ON-SITE SEWAGE DISPOSAL SYSTEM
HOWARD COUNTY HEALTH DEPARTMENT
BUREAU OF ENVIRONMENTAL HEALTH
3525-H ELLICOTT MILLS DRIVE, ELLICOTT CITY, MD 21043
TAX ID # 05-407575

SUBDIVISION: Waterford LOT NUMBER: 17

ADDRESS: 12931 Wexford Park PROPERTY OWNER: Adekunle Awojobi

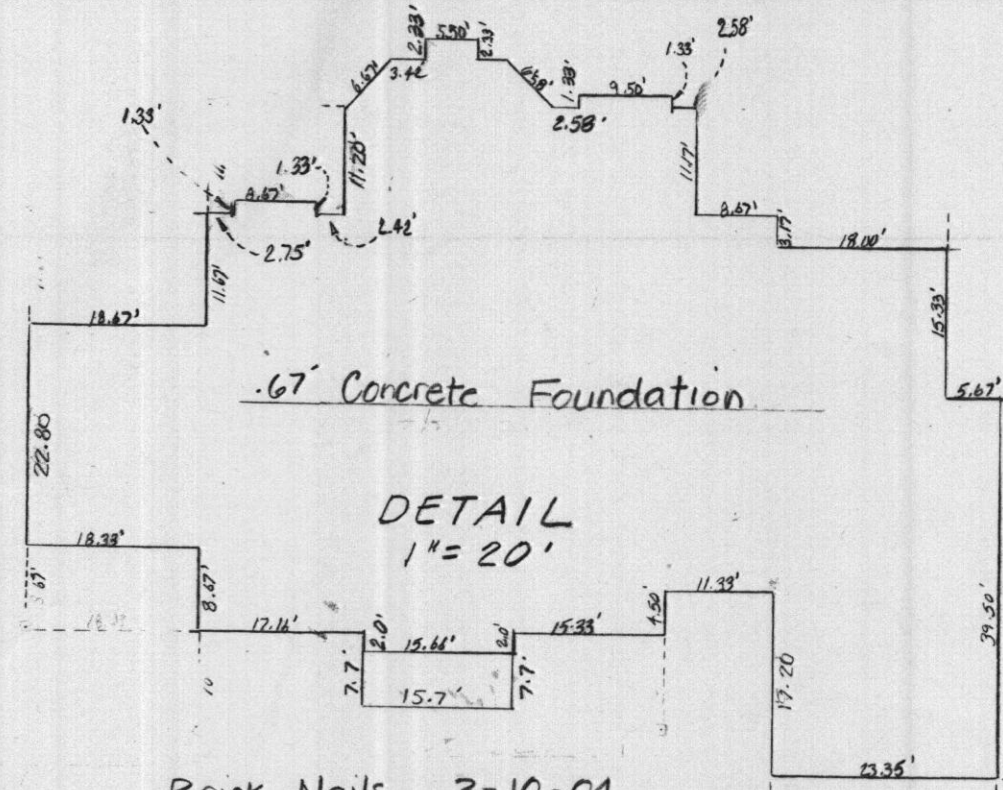
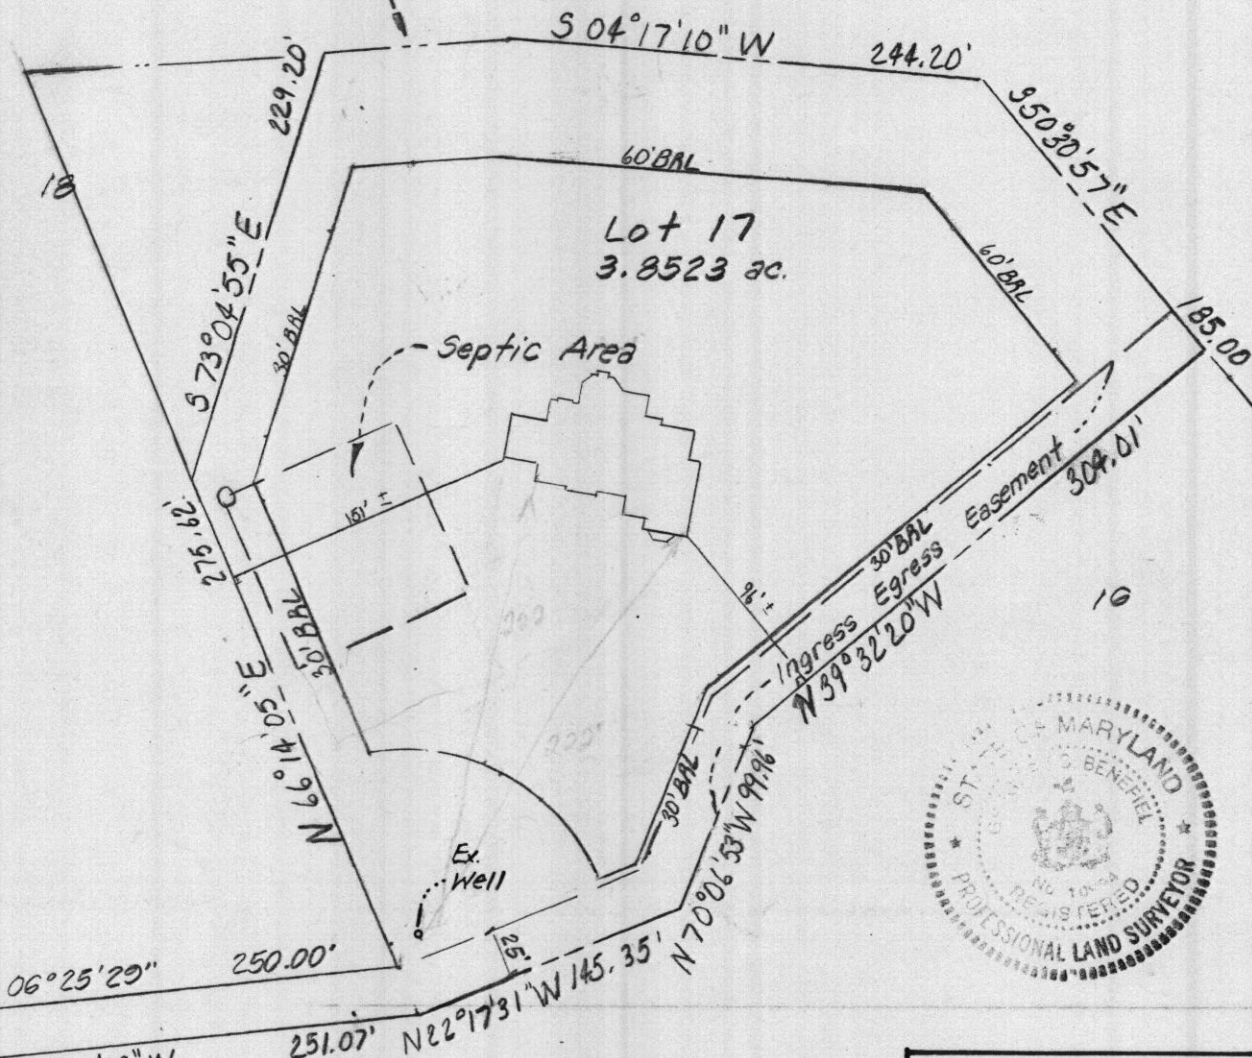
PRE-CONSTRUCTION 3/14/05 Easement not staked. Builder must get staked.

There may be a problem with water drainage through part

INSTALLATION of the easement. (BB) 3/18/05 Septic easement location

not platted correctly. Upper perc. test holes above easement.

To install pump chamber to pump to upper area when repairs

are required. Otherwise, put distribution box above the

center of the top of the easement and run 3-70' trenches on

contour towards the house. Fill in swale with excess dirt. (BB)

3/30/05 First tank set. House connection made. Line sleeved with (BB)

3/31/05 System finished. O.K. to cover everything. (BB)
